SERVICE BULLETIN NO. MSB1078-163

ATA-Code: 20-10 Standard Practices - Airframe
 57-10 Wing Structure

G 115C/D/E/EG

Fig.1

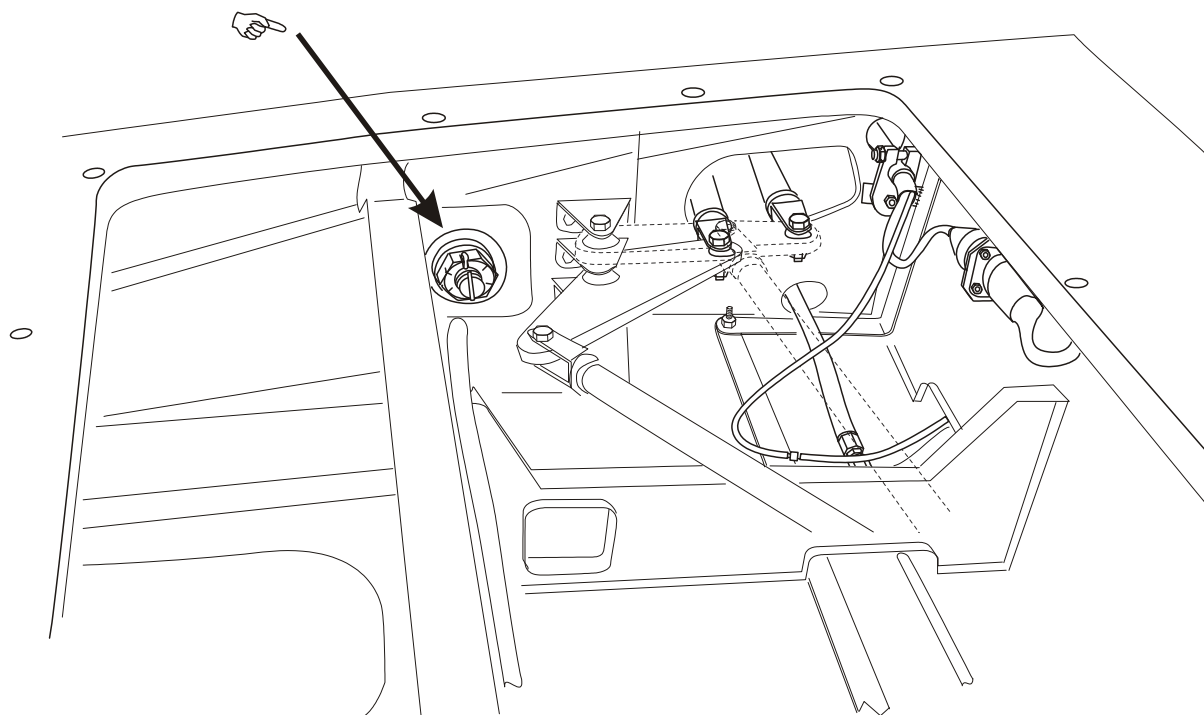
- 1.8.1. Ensure that the aircraft is safe for parking I.A.W. MM chapter 10-10.
- 1.8.2. Remove the baggage compartment panel to get access to the RH and LH rear wing shear bolts (Fig. 1) I.A.W. MM chapter 25-10.

Fig. 2

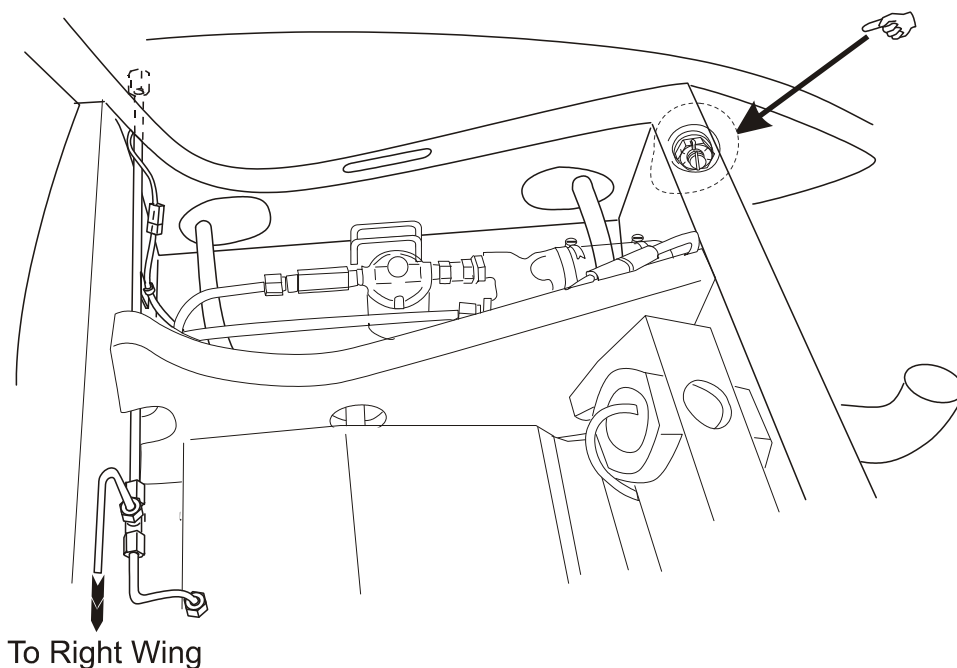
- 1.8.3. Release the cockpit trim panel in front of the pilots seat to get access to the RH and LH front wing shear bolts I.A.W. MM chapter 25-10 (Fig. 2).

Fig. 3

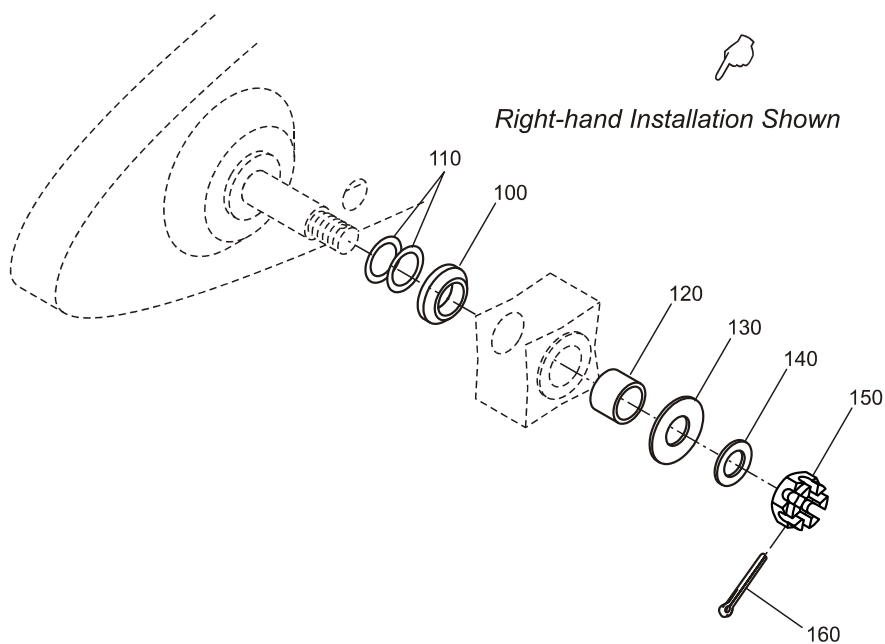
- 1.8.4. Remove cotter pin LN94-4x30 (Fig. 3, item 160) from each wing shear bolt.

- 1.8.5. Release castellated nut P/N LN9345-M16x1,5 (Fig. 3, item 150) as follows:

- turn open both nuts a half turn
- if washers underneath are turnable, the shimming between wing and fuselage is correct and you may proceed with para. 1.8.6
- if washers underneath is not turnable, proceed as follows:
 - release castellated nuts further stepwise by 1/3 turns until washer is turnable. Note number of 1/3 turns to determine required additional shims (1 whole turn = 1.5mm, thread pitch)
 - remove wing I.A.W. MM chapter 57-10
 - install additional shims P/N 115C-1001.28 (Fig. 3, item 110, thickness 0.5mm) as required
 - install wing I.A.W. MM chapter 57-10

1.8.6. Torque each castellated nut with **20 - 50 Nm (14.75 – 36.87 lbf.ft)**.

1.8.7. Install cotter pin LN94-4x30 to each wing shear bolt.
